Department of Sustainable Planning
and Community Development
City of Victoria
1 Centennial Square
Victoria BC V8W 1P6

**Re: 2659-2629 DOUGLAS STREET HERITAGE BUILDING
TAX INCENTIVE PROGRAM THIRD-PARTY STRUCTURAL ASSESSMENT**

Glotman Simpson Consulting Engineers are pleased to provide the following Tax Incentive Program third-party structural assessment for the existing 2659-2629 Douglas Street heritage structure retention. The building is located at the corner of Douglas Steet and Hillside Avenue in downtown Victoria.

Figure 10 – Ground Floor Heritage Retention Plan (As Proposed by Developer)

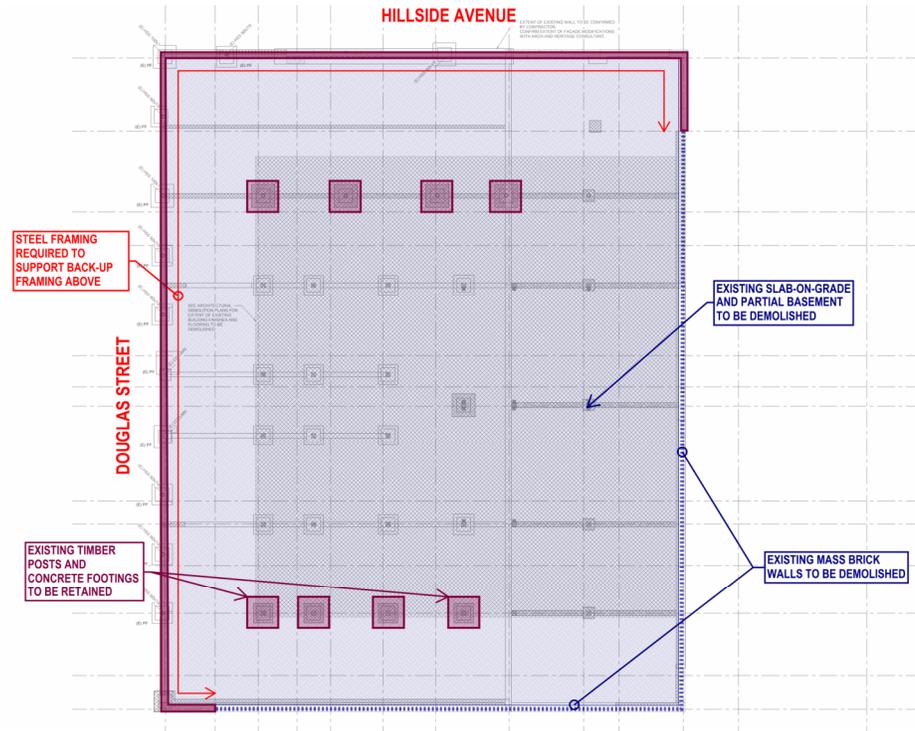
The new development has retained the following heritage items:

- Douglas Street and Hillside façade framing, including parapets and cornices
- Roughly 50% of second, third and roof level framing, including existing 2x joists, steel and timber beams, and diagonal ship-lap deck sheathing

The following items have been demolished:

- Remaining east and south mass brick walls
- Roof slab framing and supporting stud walls at second storey
- Remaining 50% of second, third and roof level framing
- Ground level foundations including concrete spread footings and slab-on-grade

Figure 11 – Second and Third Storey Heritage Retention Plan (As Proposed by Developer)

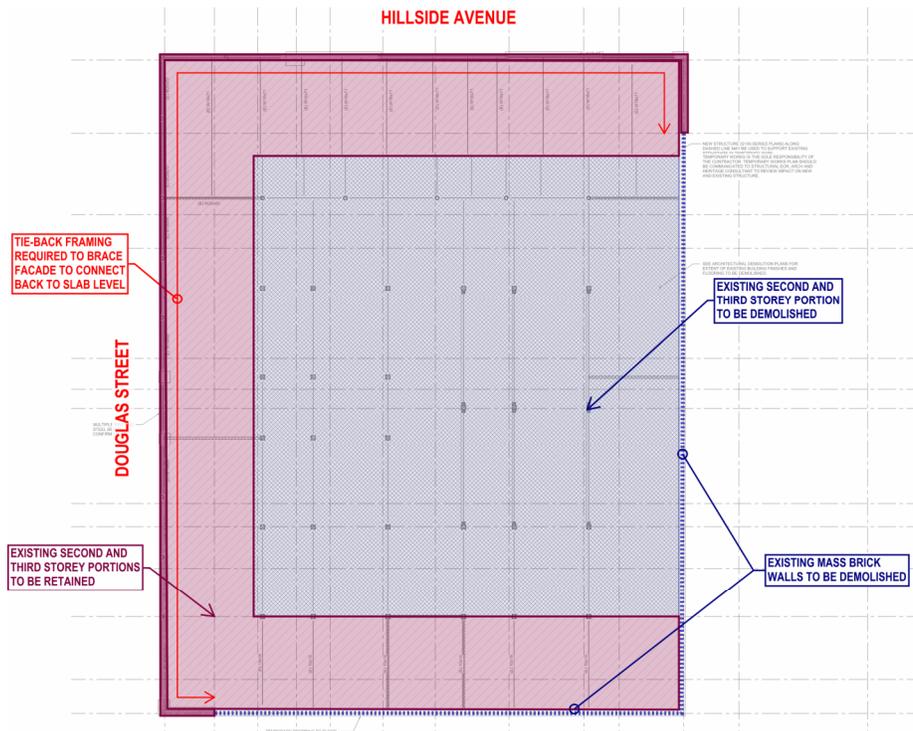
Roughly half of the existing second, third and roof level slab framing will be retained as part of the proposed new development. The existing 2x joist framing and supporting steel and timber beams will be upgraded to increase their gravity load capacity by sistering the joists and reinforcing the beams. The existing diagonal ship-lap deck sheathing does not have sufficient capacity and will be supplemented with new plywood sheathing and reinforced concrete topping to provide additional capacity.

Figure 12 – Roof Level Heritage Retention Plan (As Proposed by Developer)

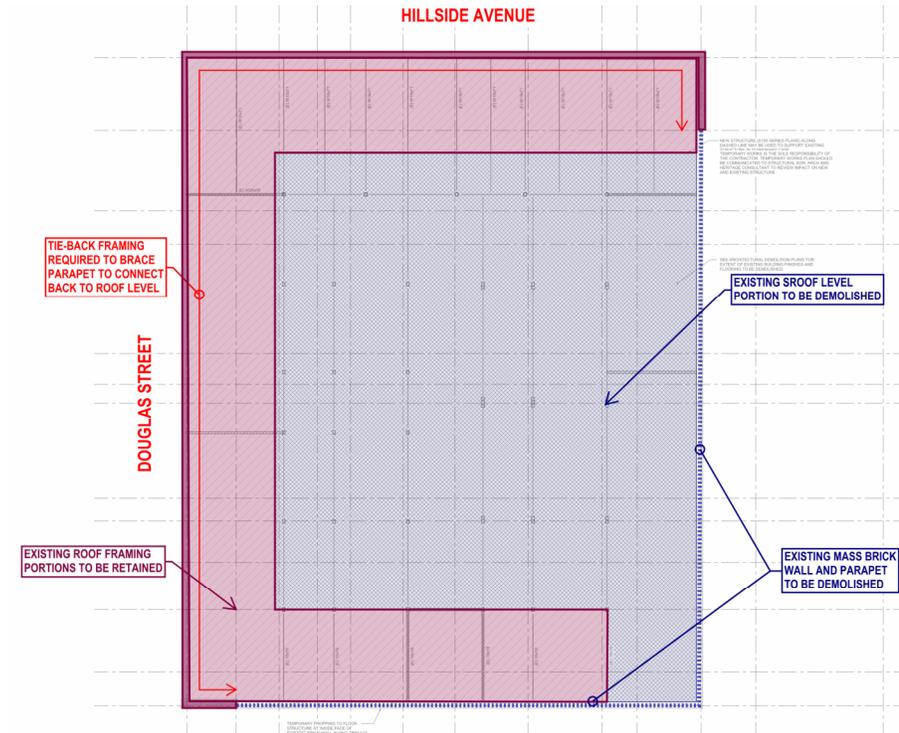
All of the lateral load capacity and stiffness is being provided by new concrete shearwalls. The new concrete topping slab is being used to drag seismic loads back to these new shearwalls.

Figure 13 – Ground Level Façade Back-Up Framing along Pandora (Horizontal dashed lines denote steel stud framing; vertical solid lines denote wide-flange steel strong-back)

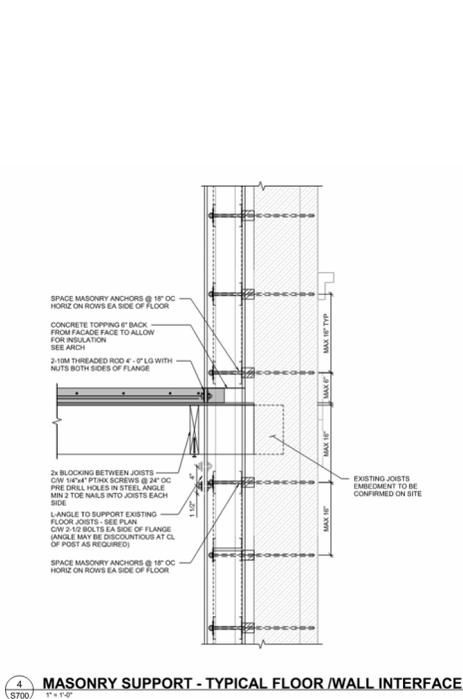
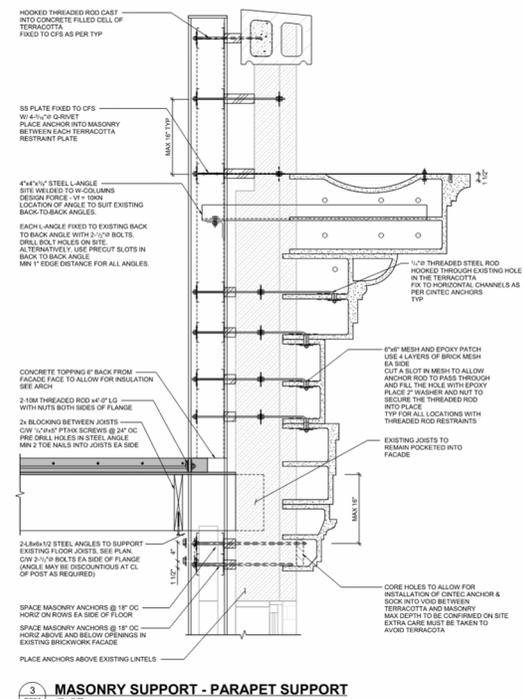
The brick façade does not have sufficient out-of-plane capacity to resist horizontal lateral movement in a seismic event (i.e. pulling away from the main building) and will require back-up framing. The facades will need to be tied back to the second, third and roof level framing with supplemental drilled and epoxy-grout embedded threaded dowels connected to steel strong-back beams and posts. Additional framing is also required to support the parapet at the roof level. Refer to Figures 11, 12 and 13 for drawing schematics of the dowel design and layout, as well as Figures 5 and 7 for in-situ placement of the framing. Additionally, there is very little in-plane stiffness or strength for the brick to act as a shearwall along the lengths of the wall; tie-in to the slab diaphragms is essential for bracing against out-of-plane and in-plane loading. New plywood sheathing and steel plate drag struts are required to brace back these elements to the new concrete shearwalls.

BUILDING A - LEVEL 2 PLAN
1/8" = 1'-0"

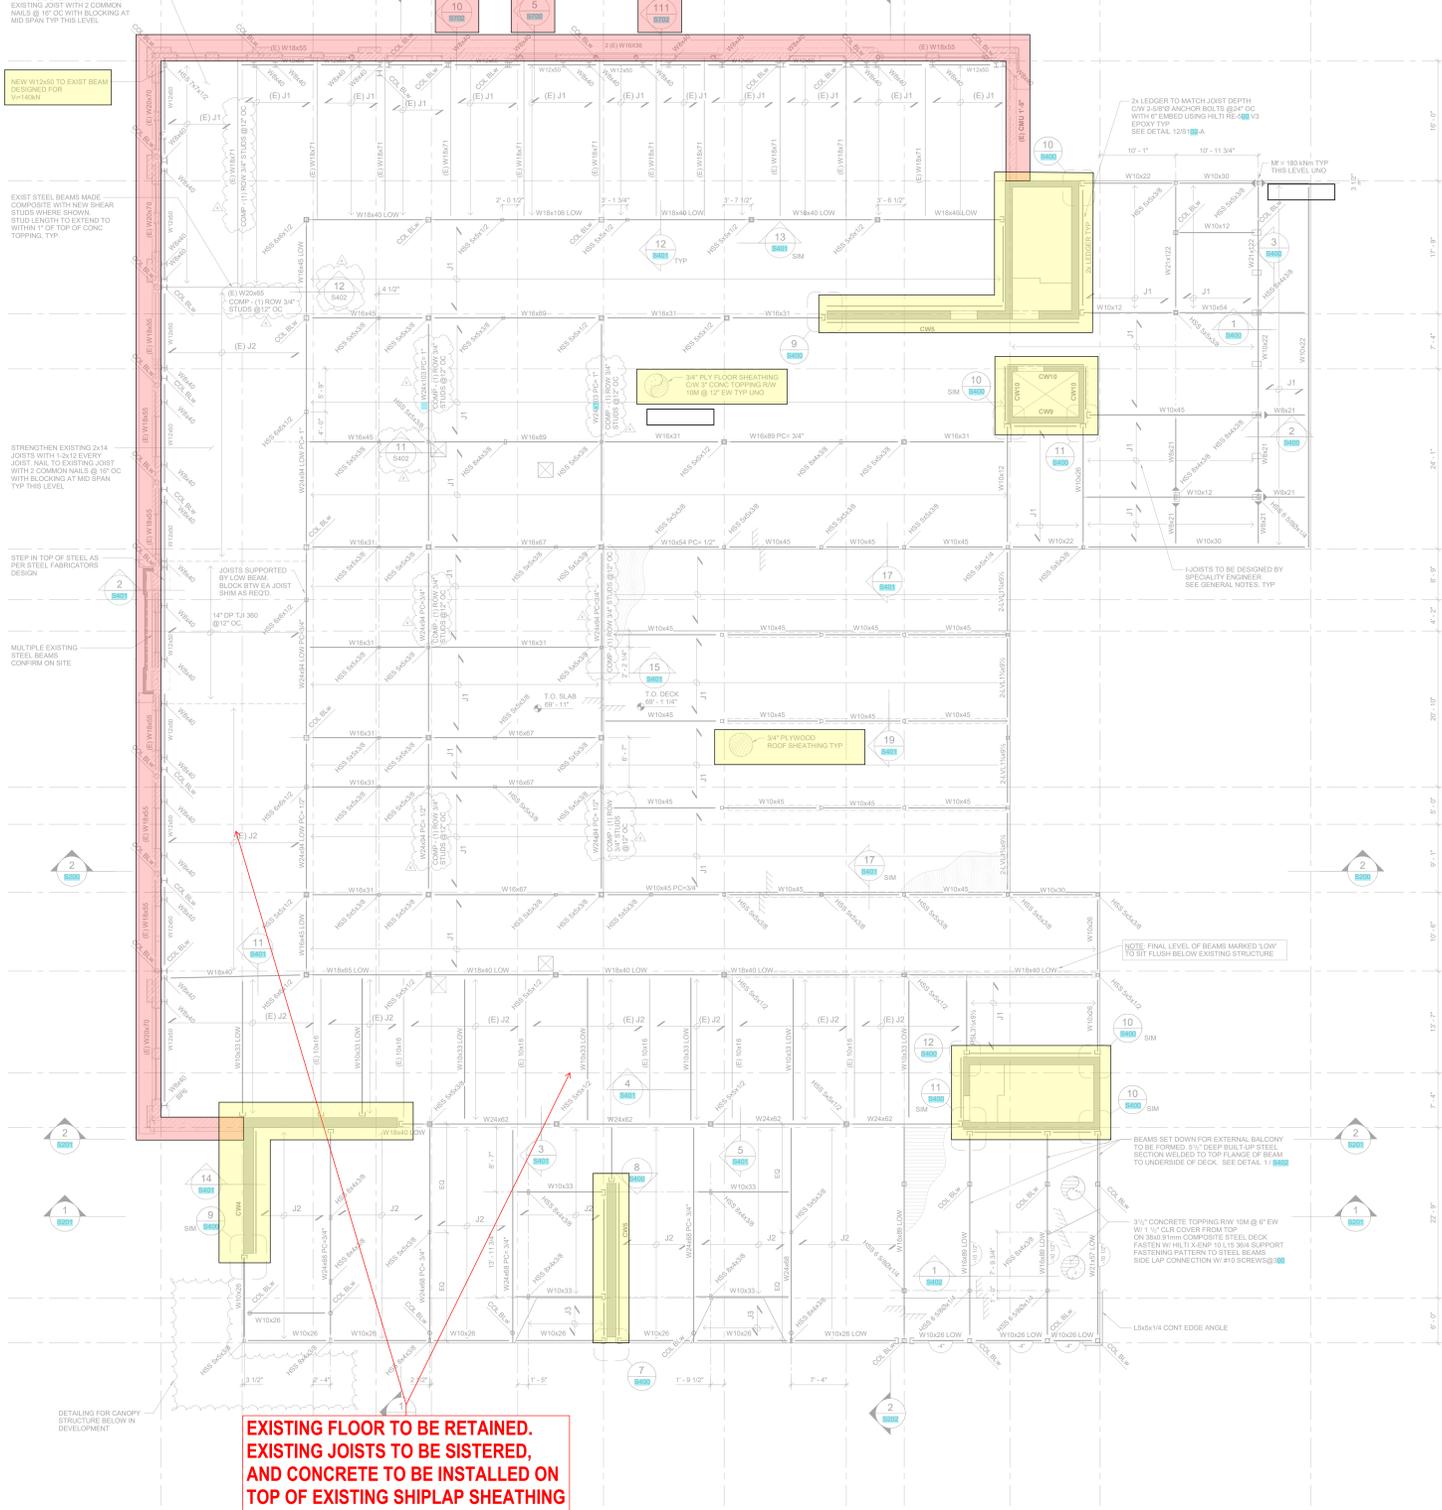
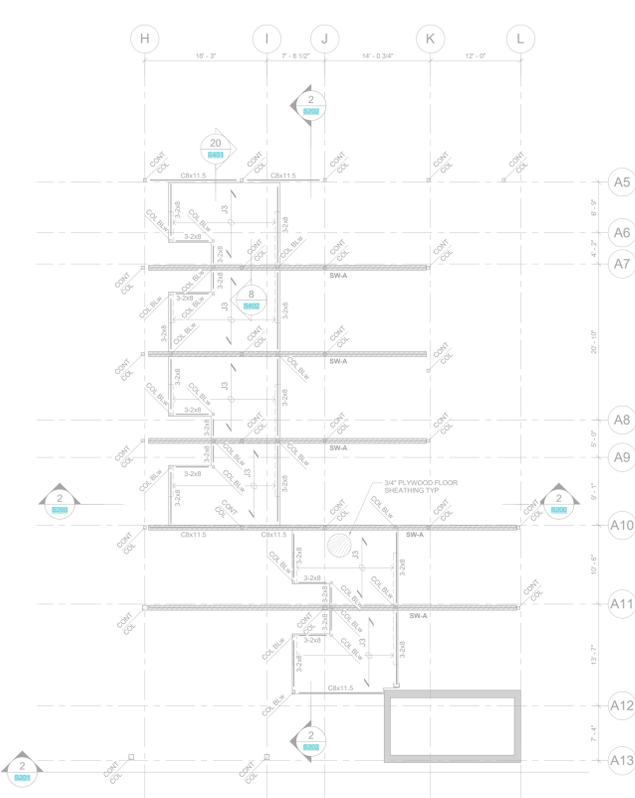
ITEMS HIGHLIGHTED IN RED ARE REQUIRED FOR DIRECT SEISMIC RESTRAINT OF HERITAGE COMPONENTS
ITEMS HIGHLIGHTED IN YELLOW ARE PARTIALLY REQUIRED FOR SEISMIC RESTRAINT OF HERITAGE COMPONENTS. REFER TO REPORT FOR DISCUSSION OF THE CALCULATED CONTRIBUTION PORTION

EXISTING FLOOR TO BE RETAINED.
EXISTING JOISTS TO BE SISTERED,
AND CONCRETE TO BE INSTALLED ON
TOP OF EXISTING SHIPLAP SHEATHING
